NUMBER: 05-002-13

Front Brake Judder And/Or Vibration

2011-2012 (RT) Caravan / Town & Country

Fig. 1 Front Lower Control Arm

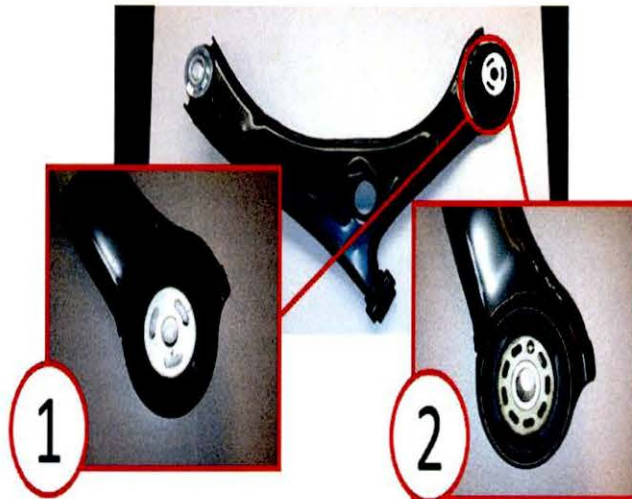
6. Remove and replace the right and left front brake pads. Refer to the detailed removal/installation procedures available in DealerCONNECT > TechCONNECT under: Service Info> 05- Brakes > Brakes, Base > Hydraulic/Mechanical > Pads, Brake, Front > Removal.
7. Inspect the bushing on the right and left lower control arm as show in ([Fig. 1](#)). Did the bushing have 8 slots as shown in call out 2 as compared to 3 in call out 1?
 - a. Yes >>> Return the vehicle to the customer.
 - b. No >>> Proceed to [Step #8](#)

1 - Replace Previous Control Arm Bushing (Metal Substrate Inner)

2 - Retain Current Control Arm Bushing (Plastic Substrate Inner)

8. Remove and replace the right and left lower control arm. Refer to the detailed removal/installation procedures available in DealerCONNECT > TechCONNECT under: Service Info > 02- Front Suspension > ARM, Lower Control > Removal/Installation.
9. Road test the vehicle for 5 miles.
10. Did any brake pedal pulsation, steering wheel shake and/or floor pan vibration exhibit.
 - a. Yes >>> Continue further diagnosis.
 - b. No >>> Return the vehicle to the customer.
11. Return the vehicle to the customer.
